ATR on Quality Control Check Repot. (Bungalows)

Quality Control Check Report. Stage: After Plumbing & Electrical (Villas)

Description	Direction	Owners & Developers	Date	Promoted by
QUALITY CHECK -ELECTRICAL PLAN OF TYPE - A2 (single)	N	Modi Properties Pvt Ltd.	01.03/18	Modi Properties Pvt. Ltd.
		Project Name & Phase:	Prepared By: Madhav	Phone:+91-40-66335551
		ACH. MIRIYAT	Approved By: Sohan Modi

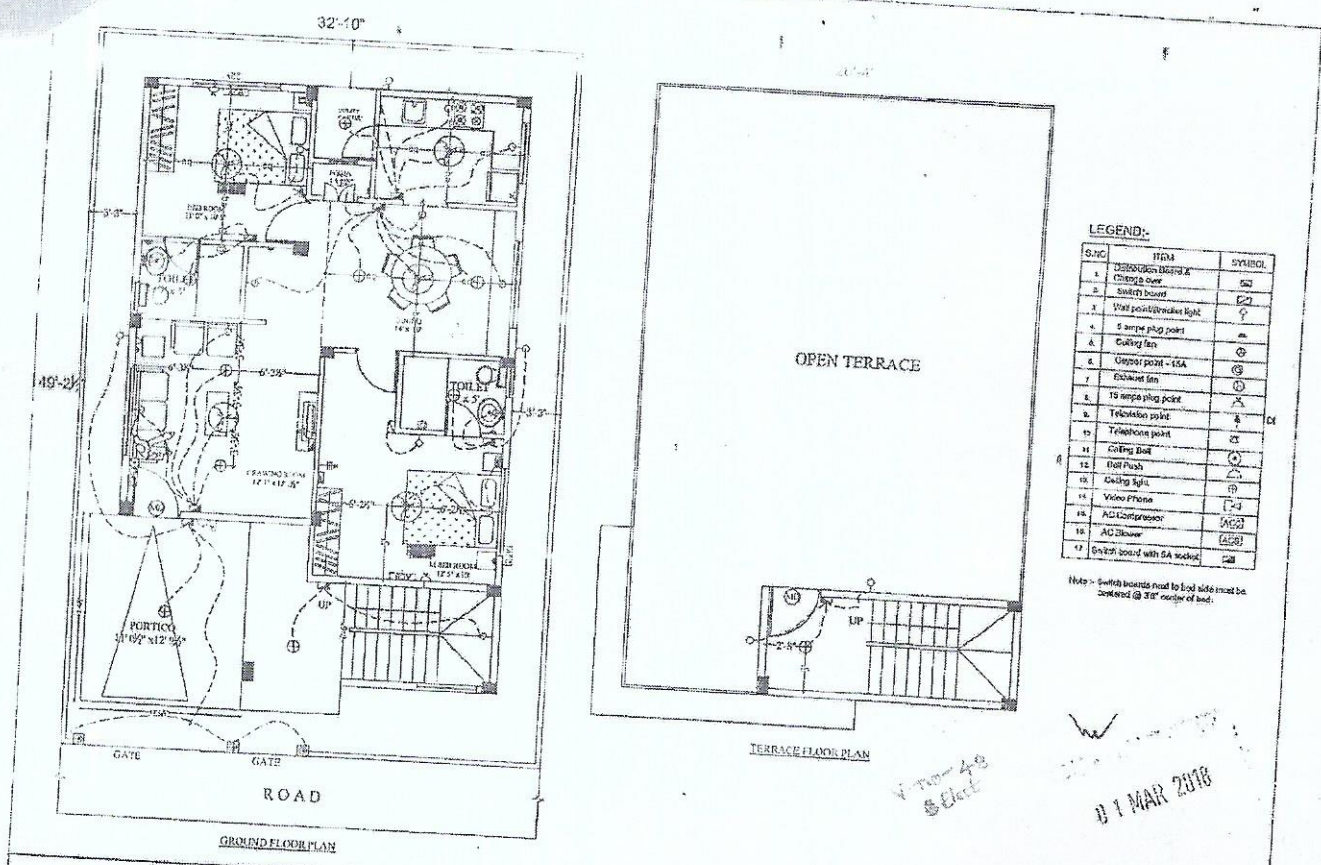
Remarks:
 (X) Bed points not as per specified hts at K.B & M.B, (X) Wall Pts not provided at Dining, Kitchen, Puja
 (X) Telephone Pt not as per specified ht at Drawing.

Certified that all corrections mentioned in the QC report have been completed. Work can proceed to next stage.

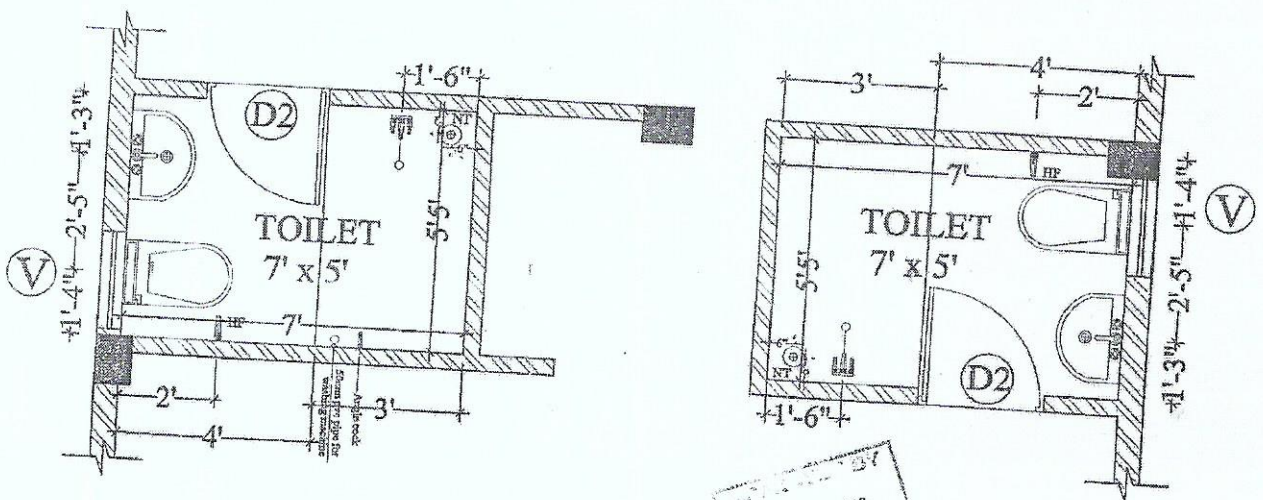
V.no-48
Plumb
